PanGEO
INCORPORATED
Geotechnical & Earthquake
Engineering Consultants

April 4, 2019
Revised April 24, 2019
File No. 14-128.200

Subject: **Response to Geotechnical Review Comments (Revised)**
Proposed Single-Family Residence
4634 E Mercer Way, Mercer Island, WA

Material Name	Color	Unit Weight (lbs/ft3)	Strength Type	Cohesion (lb/ft2)	Phi	Water Surface	Ru
Material 1		110	Mohr-Coulomb	0	28	None	0
Material 19		125	Mohr-Coulomb	0	35	None	0
Material 20		130	Mohr-Coulomb	0	40	None	0

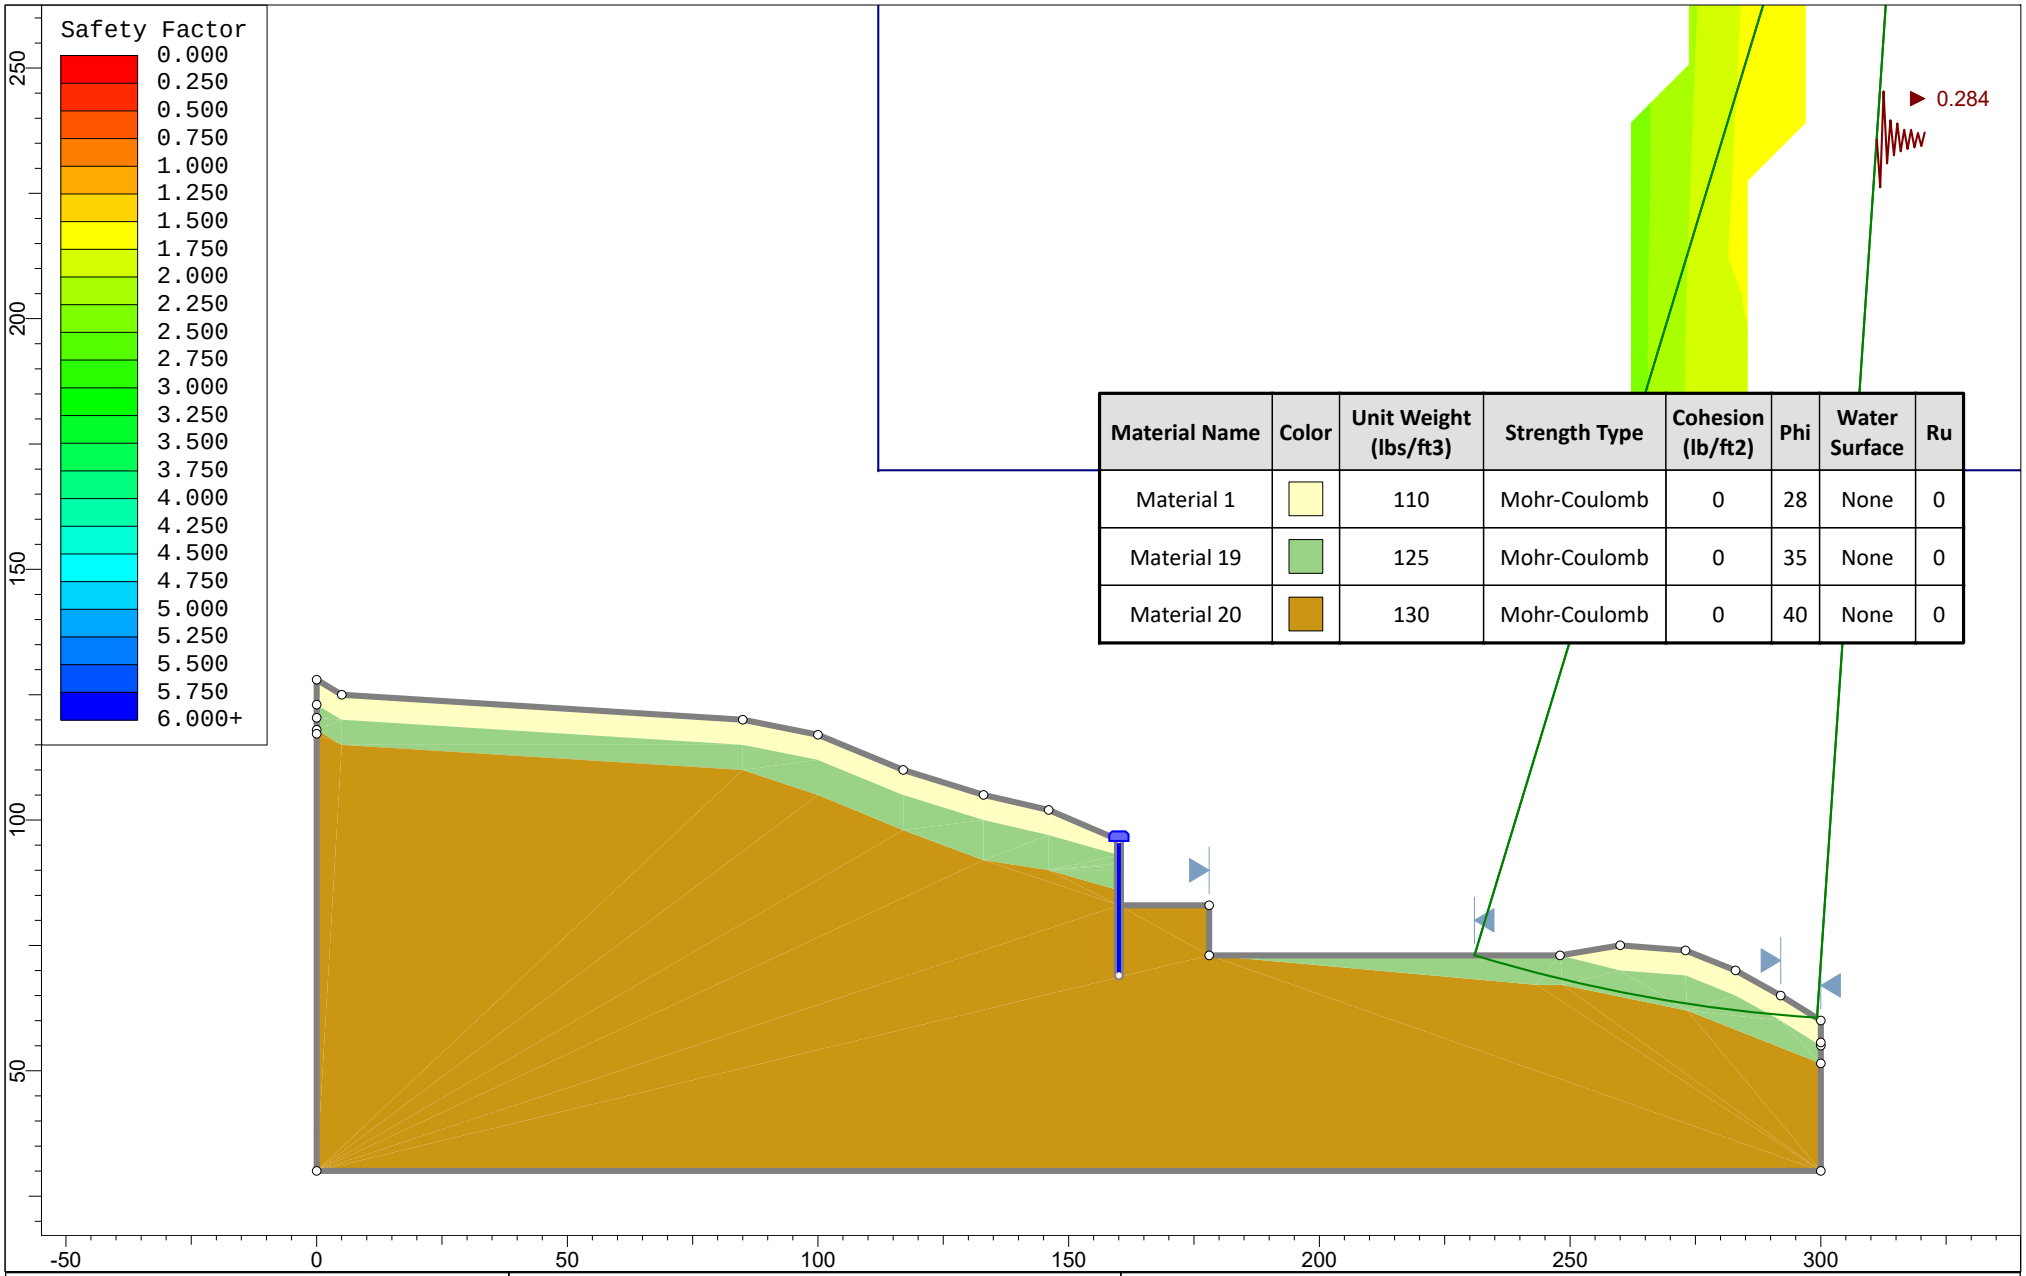
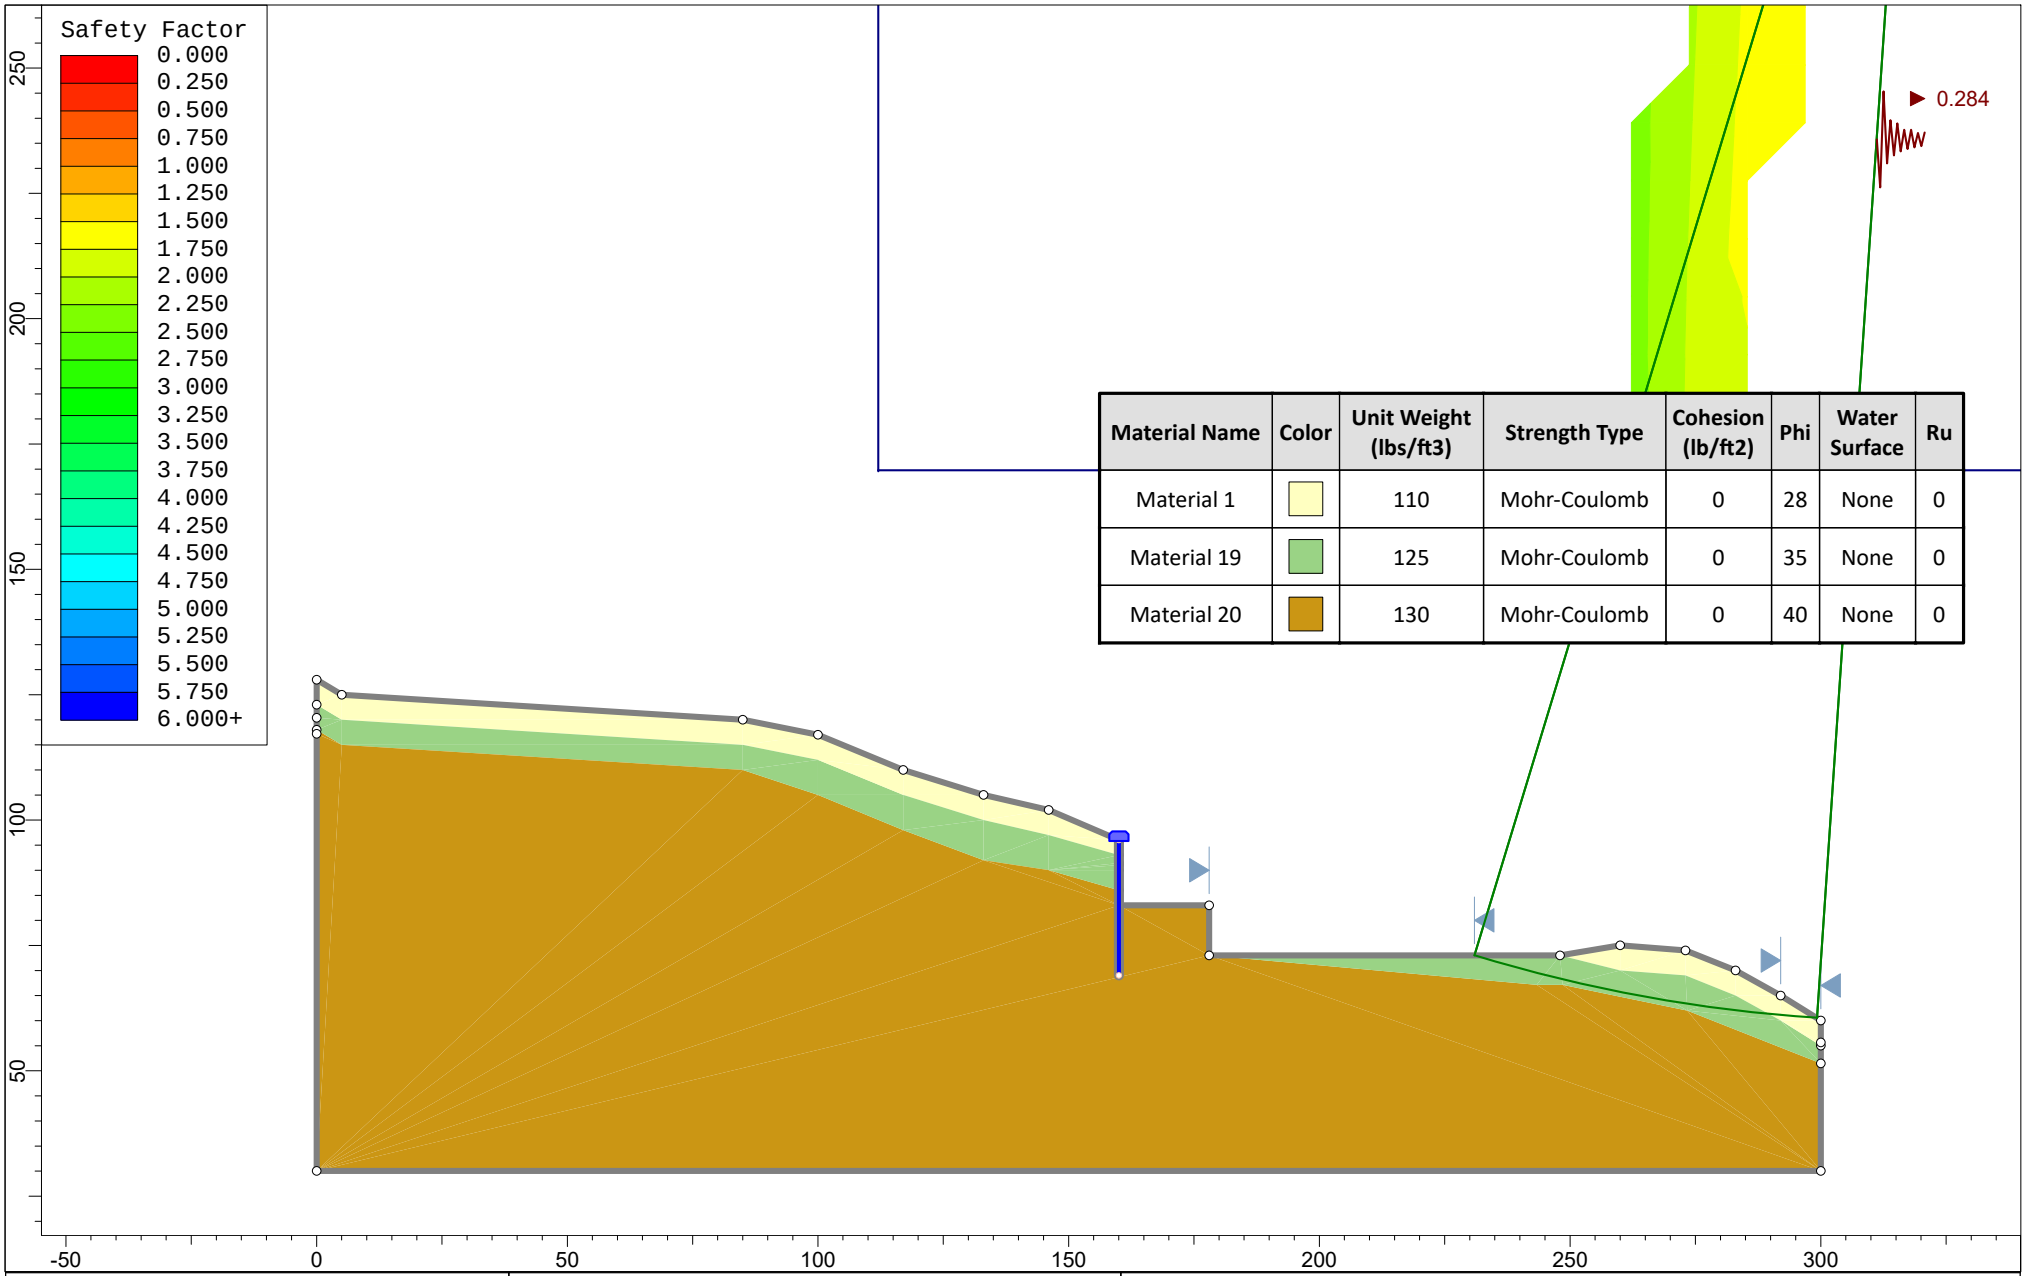
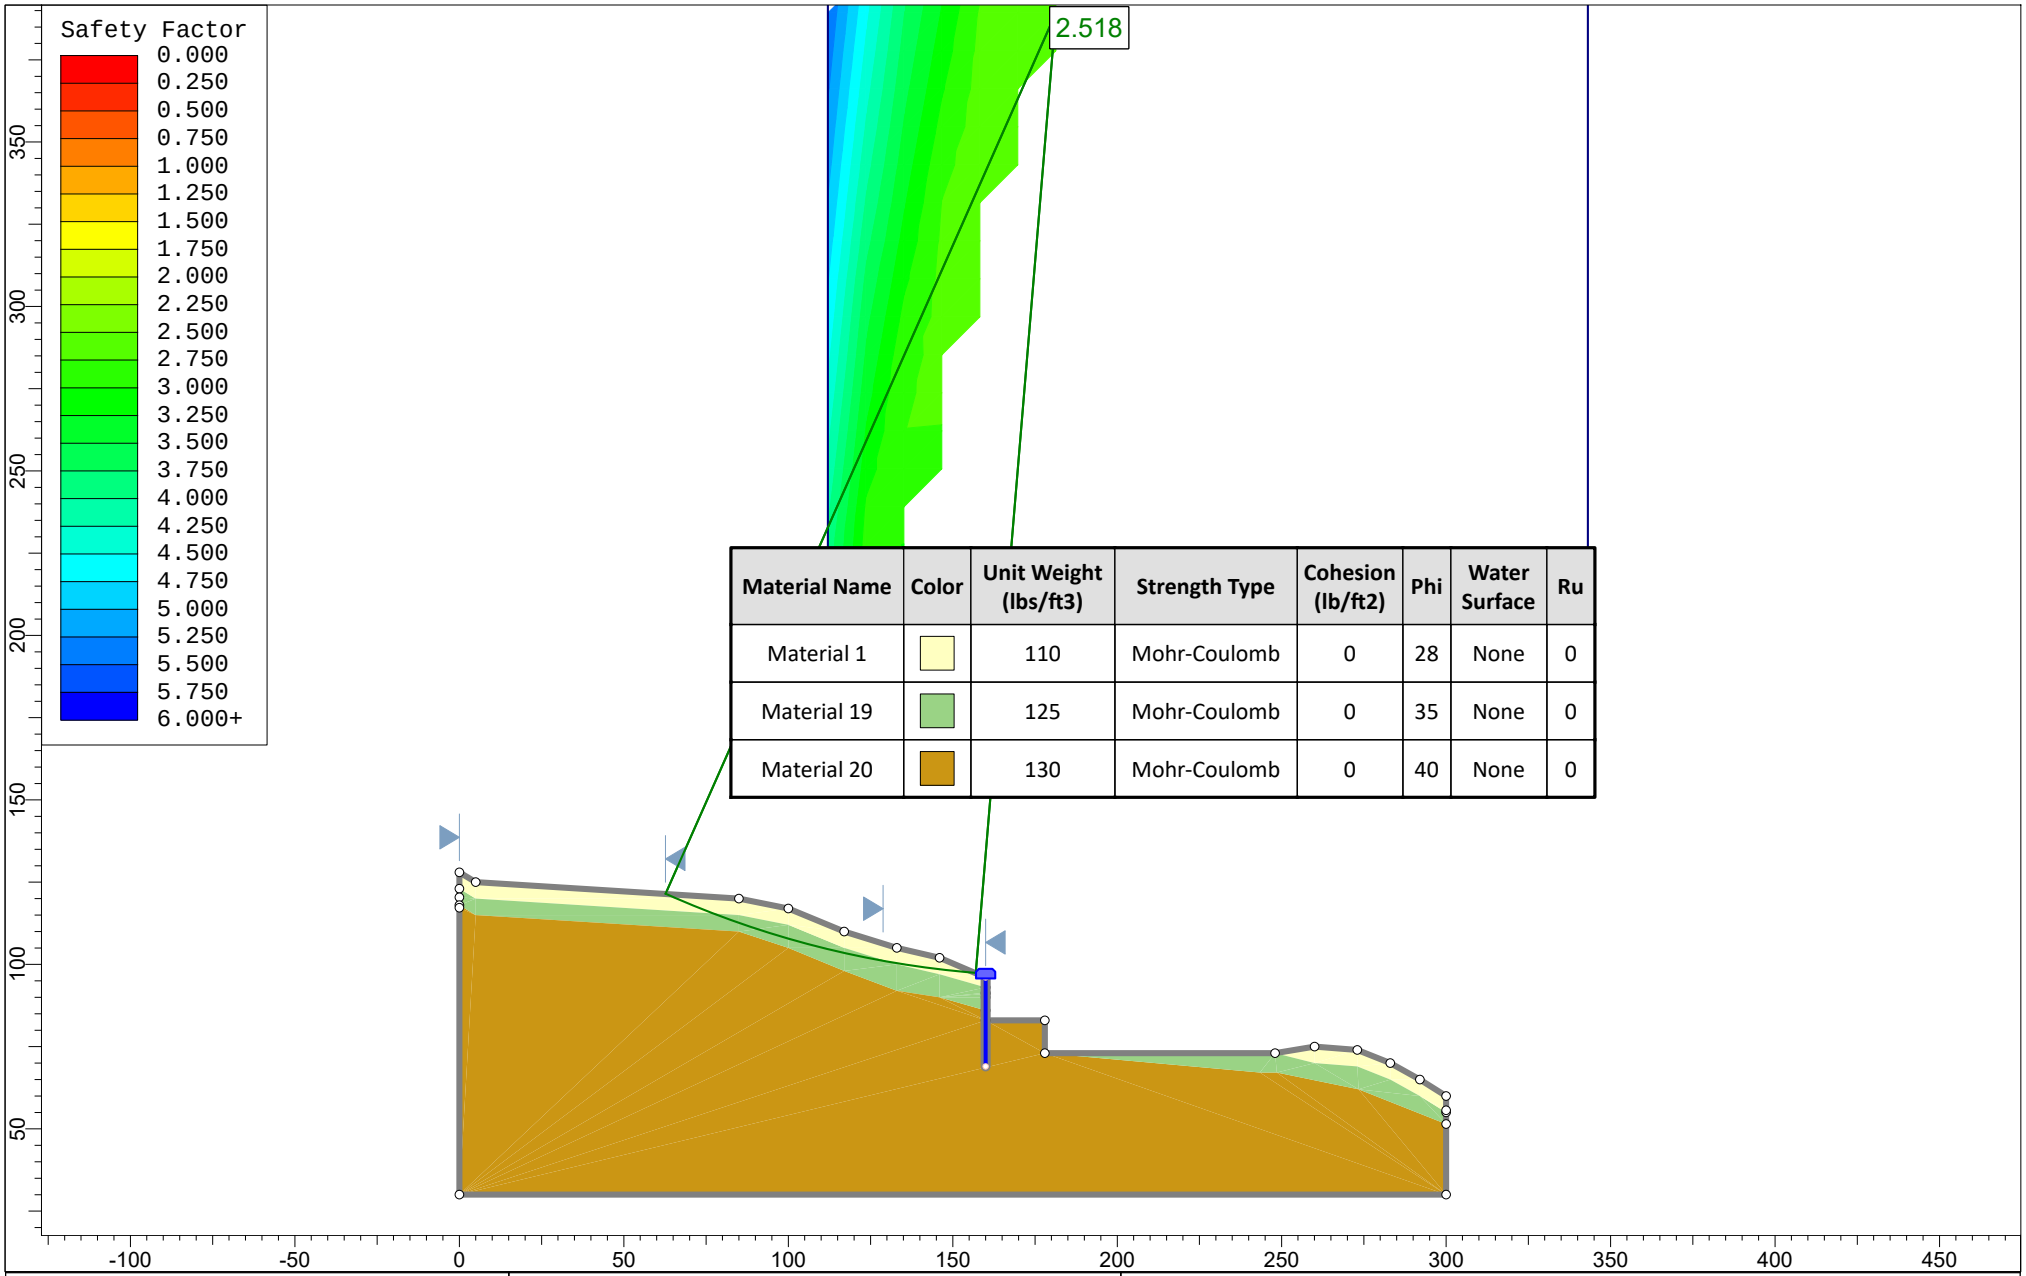
2. Overall Slope Stability analysis (Comment #2)

Our slope stability analyses were performed using the computer program *Slide v6.008* (Rocscience, 2010). The seismic stability was analyzed using pseudo-static procedures, where the effect of earthquake ground shaking is represented by the use of a "seismic coefficient" in the stability calculations. In our pseudo-static stability analysis, one-half of the expected peak ground acceleration, or 0.284g, was used. The results of our analyses are shown in Figures 4 through 8.

In summary, based on the results of our additional analysis and evaluation, it is our opinion that the site has the adequate factor of safety against potential failures under the

static and seismic conditions, and will not likely have catastrophic slope failure that may threaten life safety of the occupants.
